## SERVICE NOTES INDEX

### HP 8902A Measuring Receiver

#### Modification to resolve HP 8902A Intermittent Lockup and HP-IB Hangup.

Figure 1

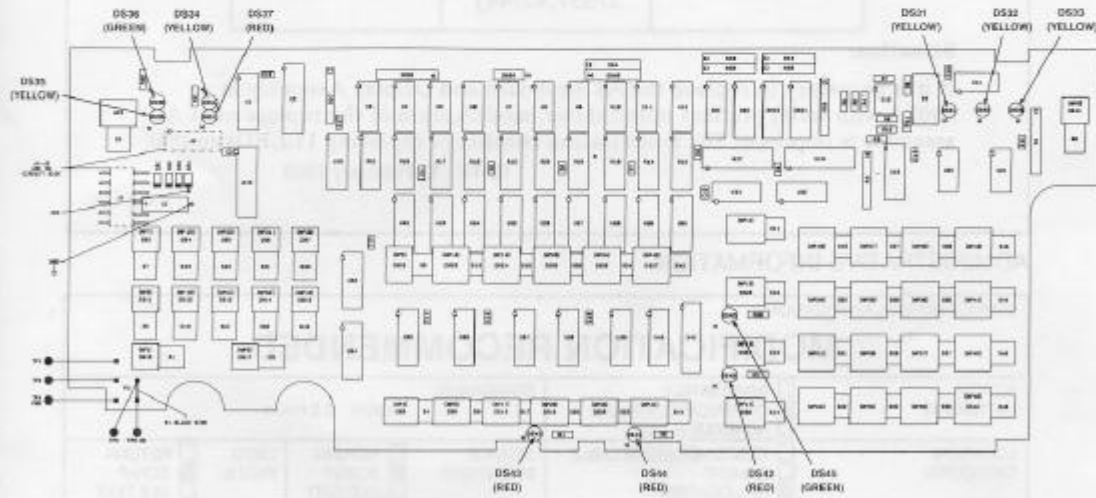
Referring to Figure 1 for LED locations on the A1 Keyboard and Display Assembly, replace the 11 LEDs using the part numbers and reference designators noted above. Refer to Volume 1 of the 8902A Service Manual, Section 8, Disassembly, Front-Panel Disassembly Procedure (Pages 8C-1 and 2). Also refer to Figure 8C-3, Illustrated Parts Breakdown of the Front Panel, (Page 8C-5). Insure proper orientation when installing the replacement LEDs.
